GE Appliances & Lighting Service Bulletin

Laundry
Models:
GTUP270EM/GM

HL01-12

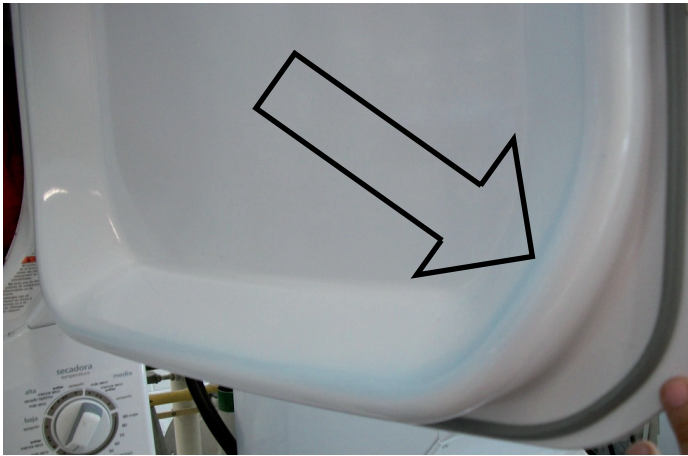
TORN CLOTHES, BUTTONS RIPPED OFF, TWISTED DRAWSTRINGS.

Clothes ripping during the drying cycle in the Unitized washer-dryer may be the result of an uneven gap between the dryer inner door and front panel. This may occur on units produced prior to January 2012 (AZ serial number).
